RE: P.Z. 02-2024 18009 and 18045 N. Outer 40 Rd. (Gumbo Flats Properties, LLC): A request for an ordinance amendment to create a new "PI" Planned Industrial District for two parcels zoned "M3" Planned Industrial District, "NU" Non-Urban District and "PI" Planned Industrial District, and totaling 78.07 acres located on the north side of Outer 40 Road (16W310045 and 16W240041).

Planning Commission Staff Report

Petition: **P.Z. 02-2024 18009 and 18045 N. Outer 40 Rd. (Gumbo Flats Properties, LLC)**: A request for an ordinance amendment to create a new “PI” Planned Industrial District for two parcels zoned “M3” Planned Industrial District, “NU” Non-Urban District and “PI” Planned Industrial District, and totaling 78.07 acres located on the north side of Outer 40 Road (16W310045 and 16W240041)

PRELIMINARY DEVELOPMENT PLAN

Sheet Title:	Tree Stand Delineation North
Sheet No.:	TSD-1
Date:	1/25/24
Job #:	813.026

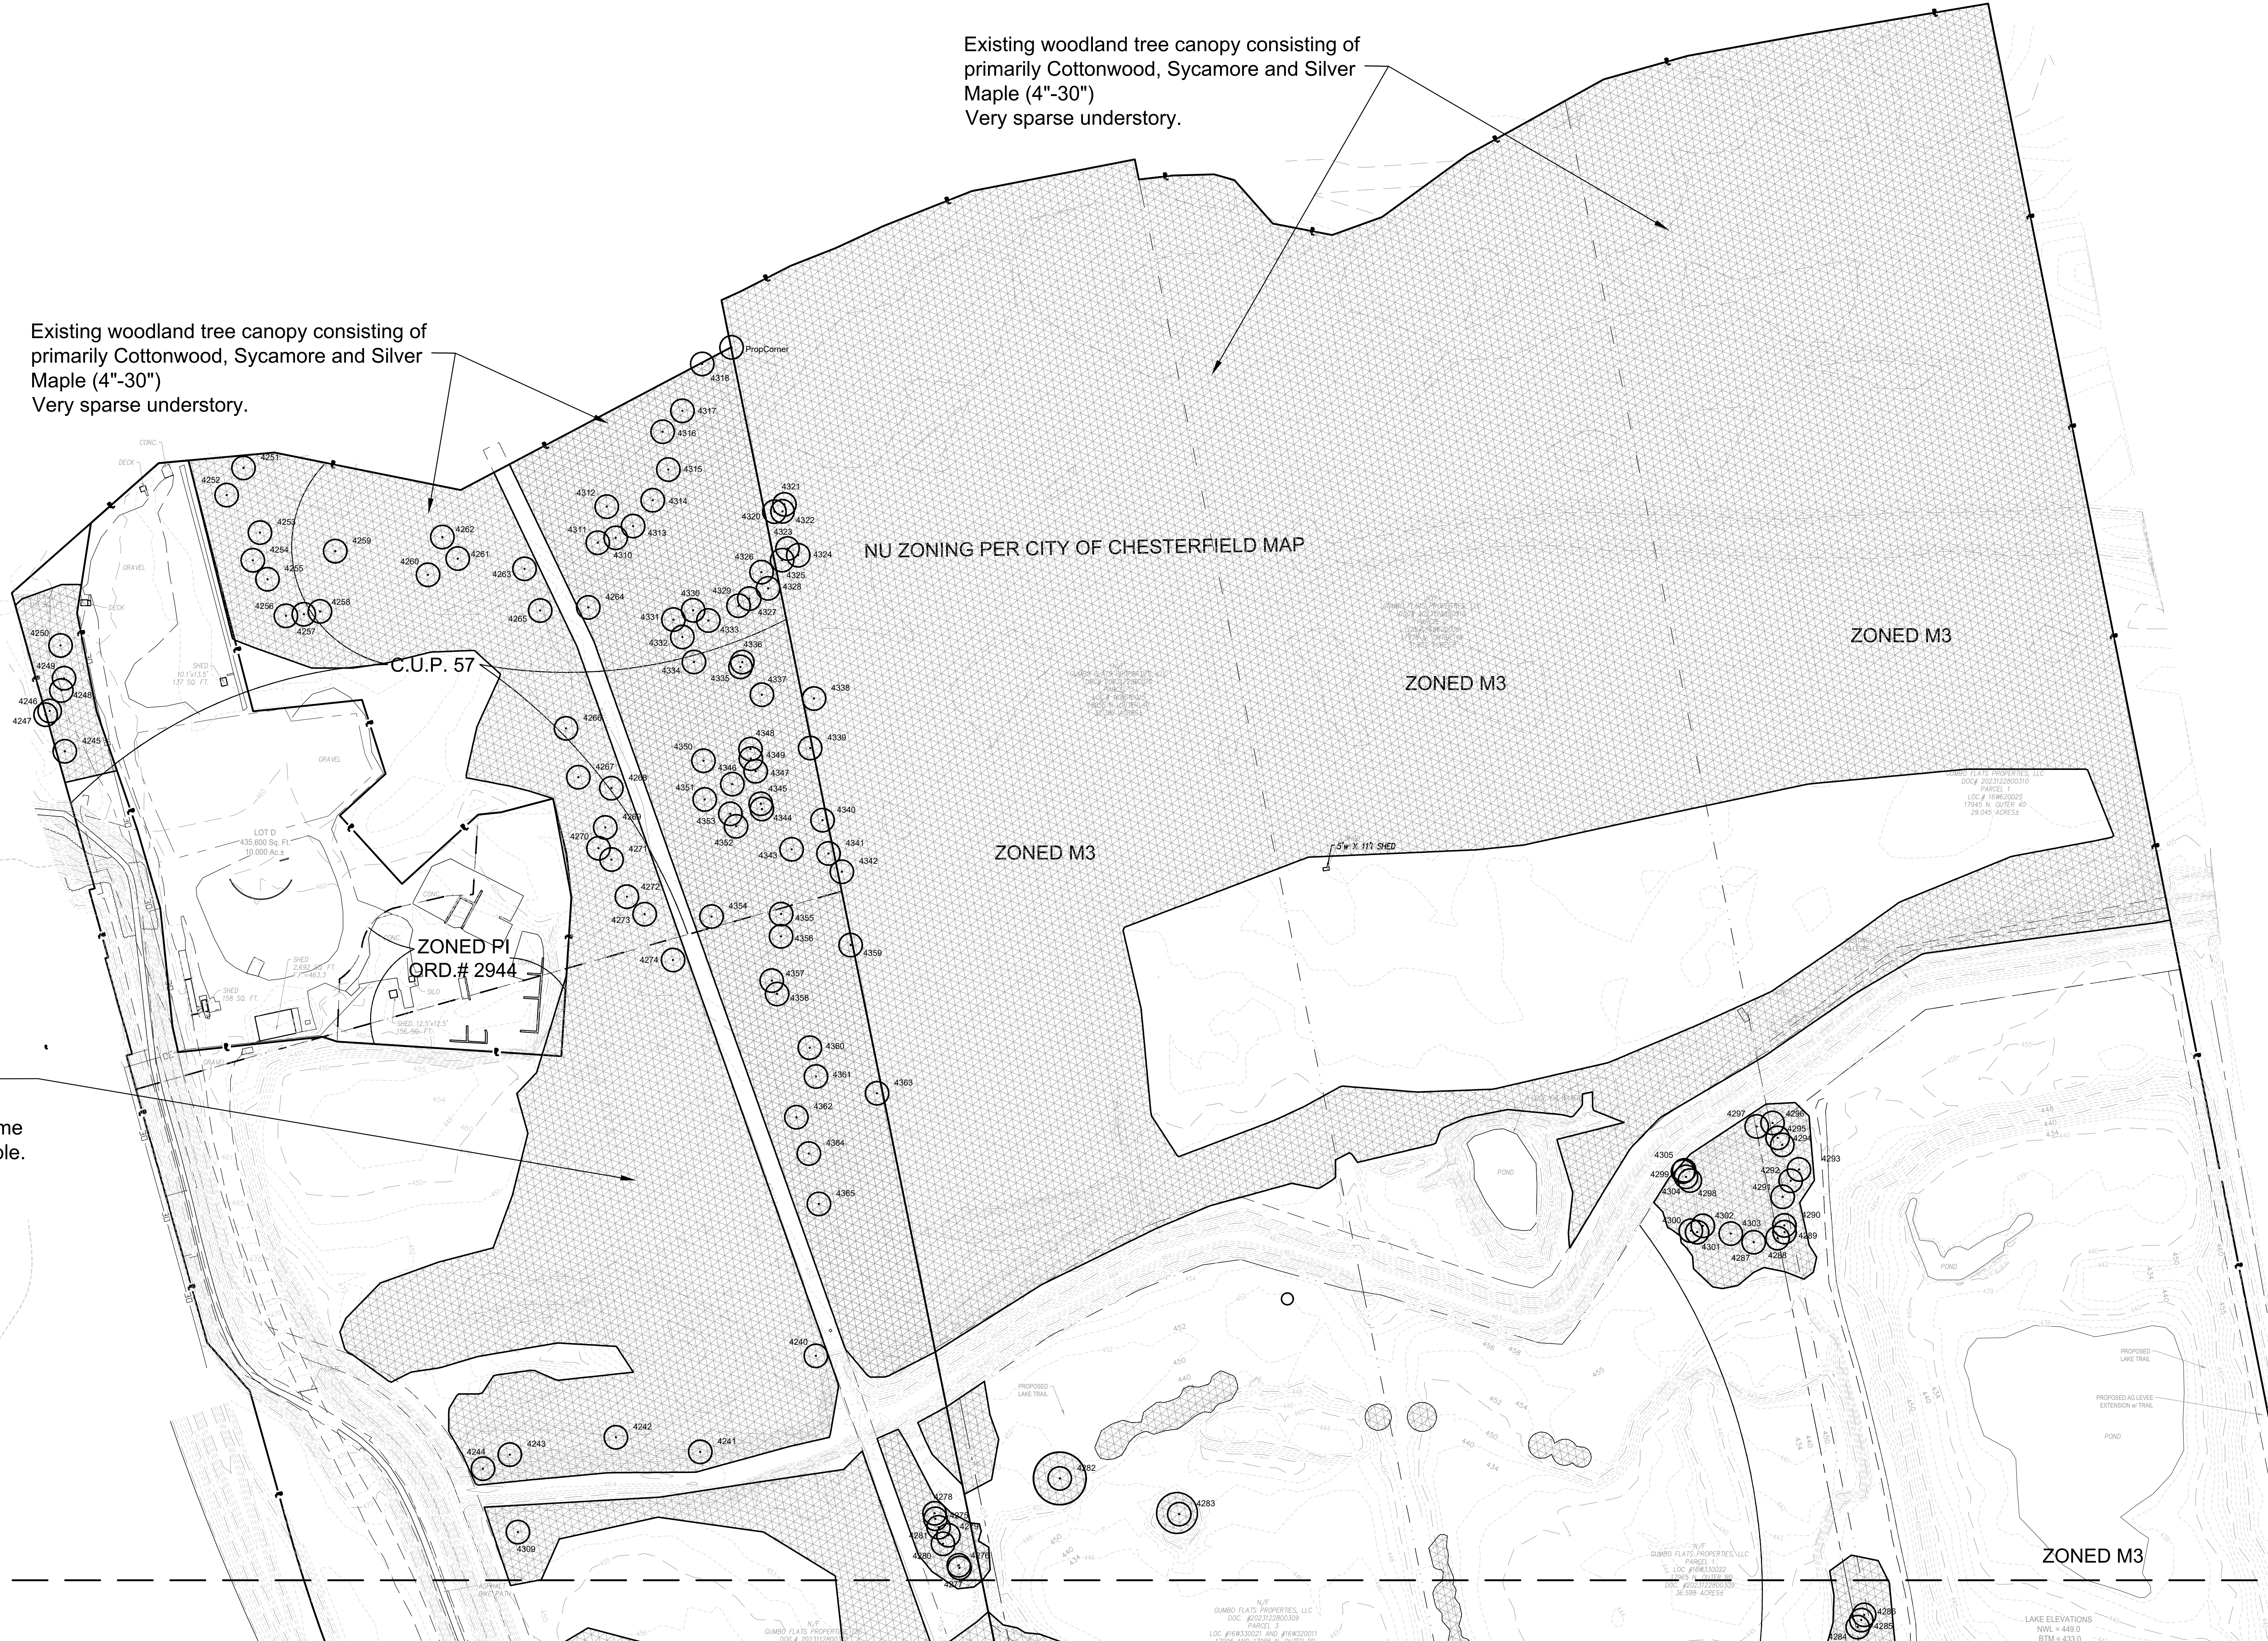
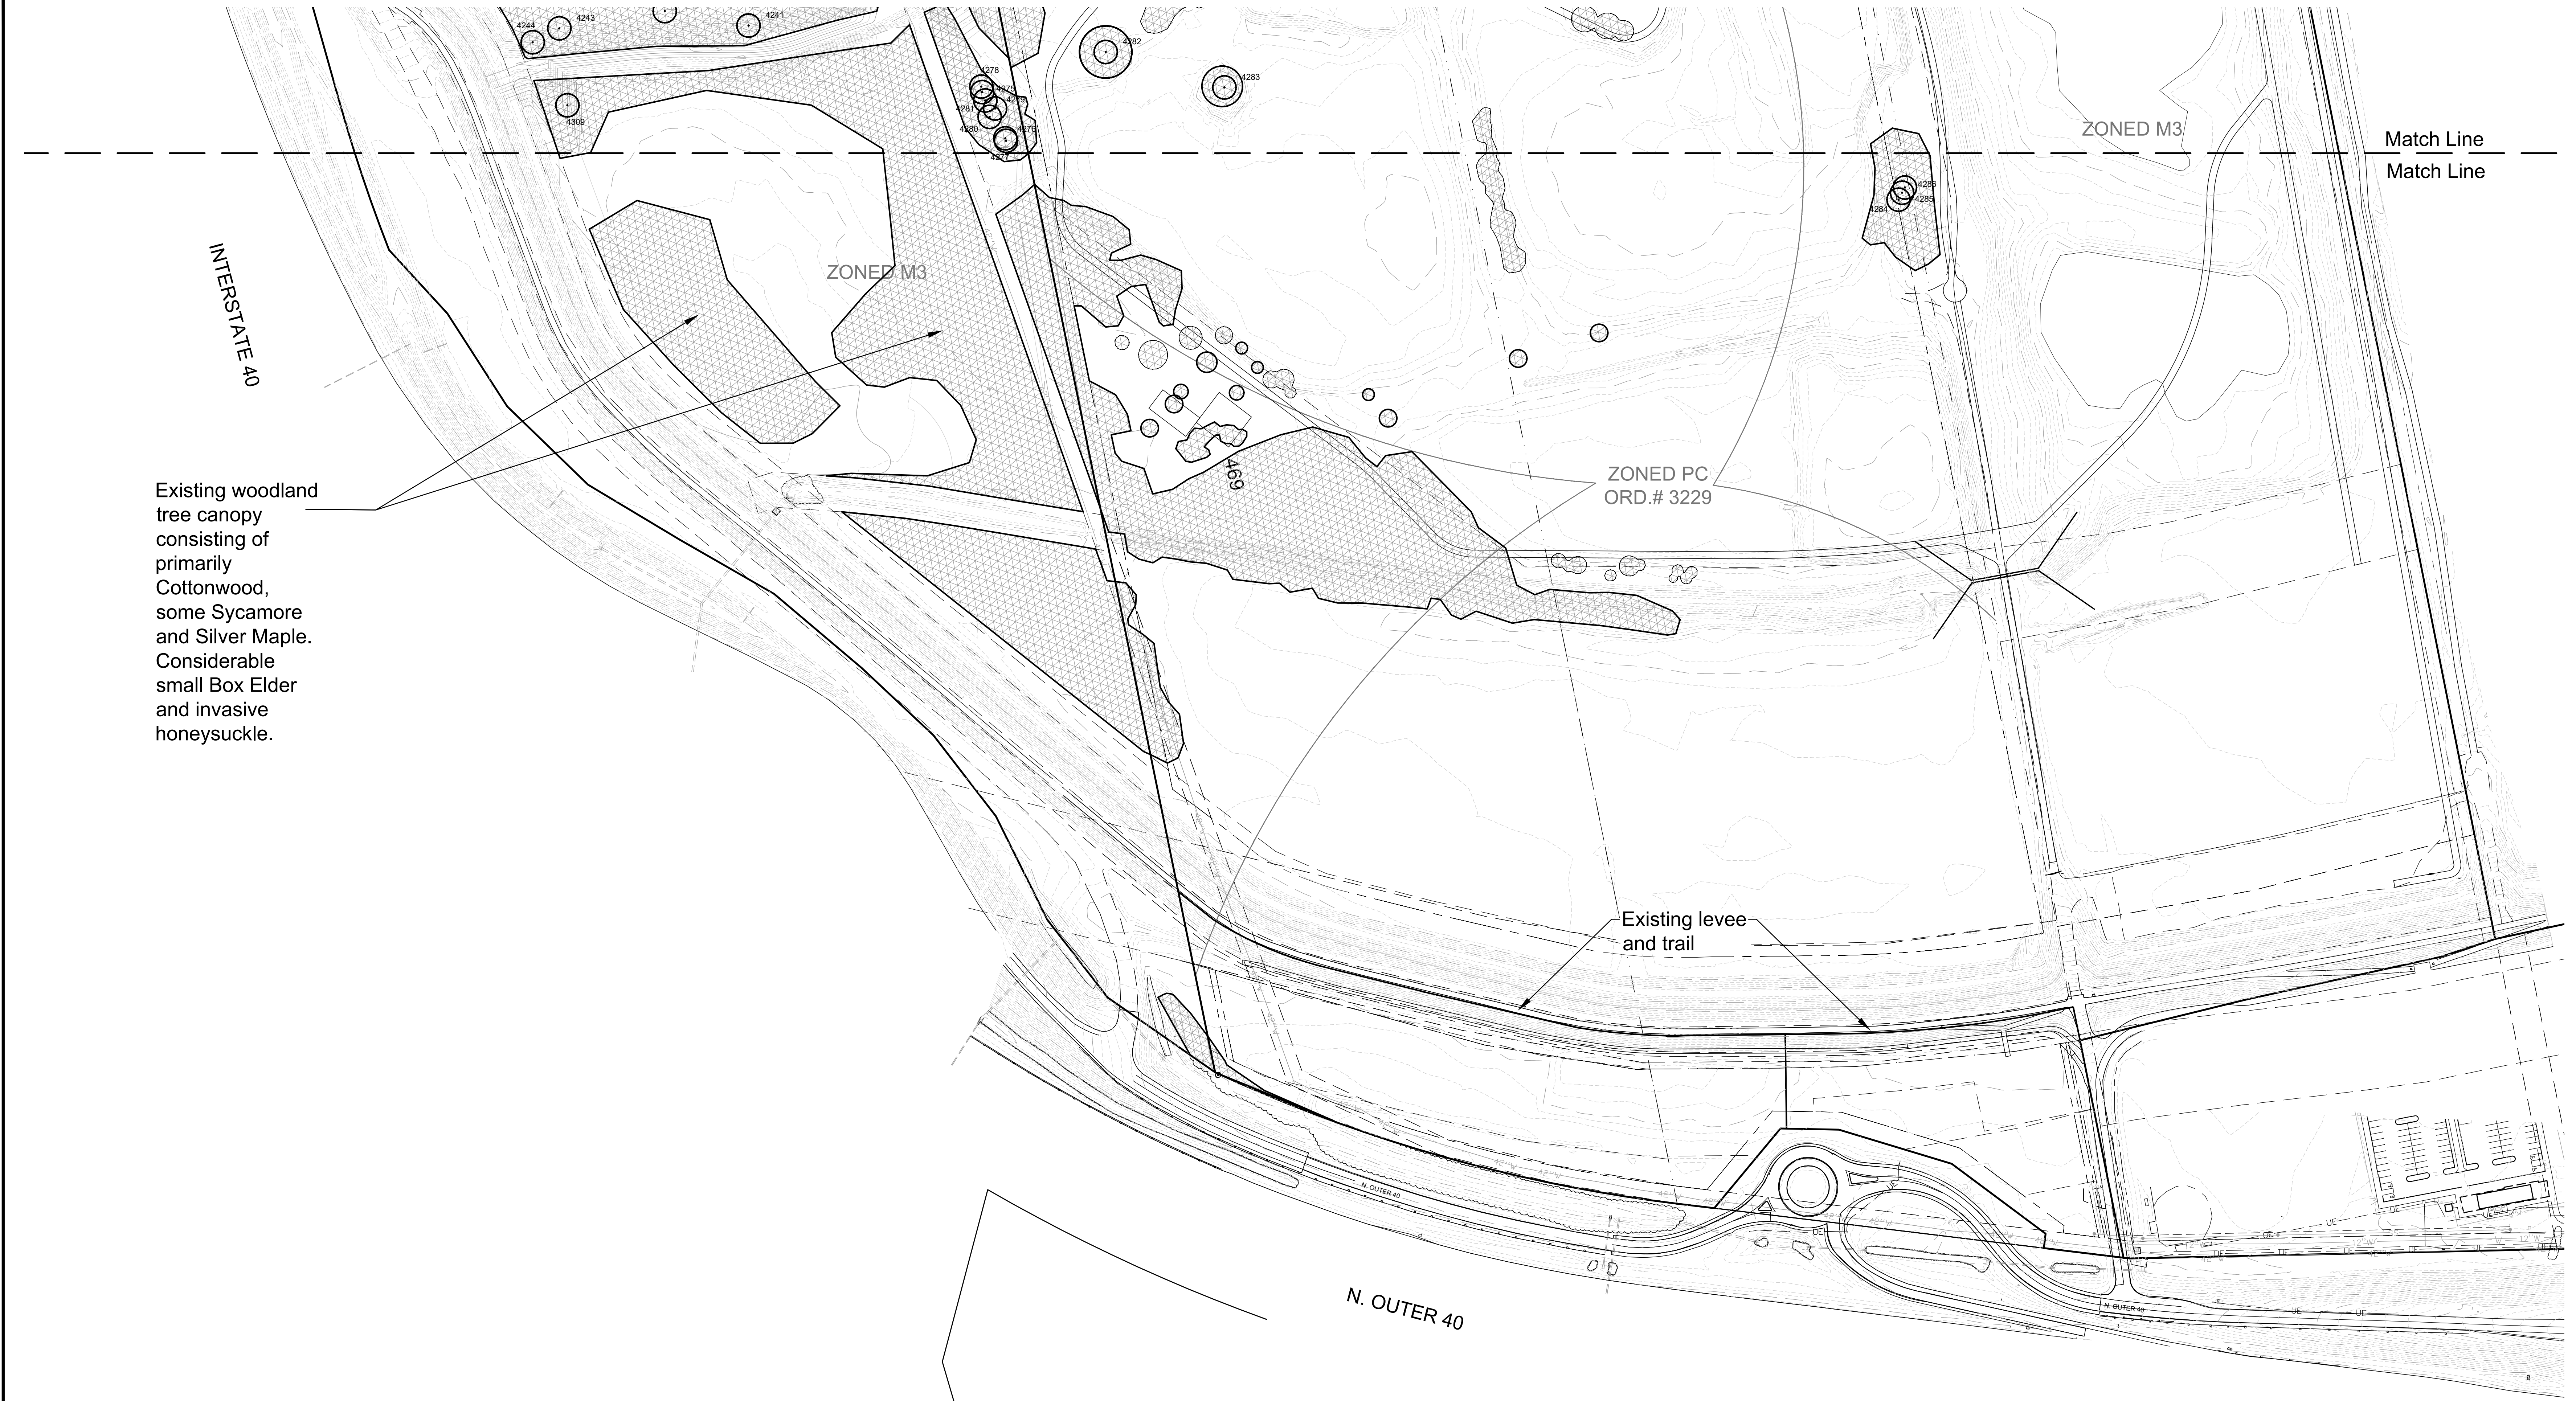
- The submitted Tree Stand Delineation is for the entire “Gumbo Flats” properties totaling 290.58 acres. As per the submitted plan, the applicant will be preserving 88.4% of the trees on site. The Tree Stand Delineation also depicts that the trees existing on the proposed gravel parking area are primarily Cottonwood, some Sycamore and Silver Maple, and considerable small Box Elder and invasive honeysuckle.

2. Concern was raised regarding the amount of tree removal associated with the proposed improvements. Please provide information on how the development team will be addressing this concern.

Response: Tree removal is limited, 11.6% being removed and 88.4% retained of the overall Gumbo Flats Property LLC. Assemblage.
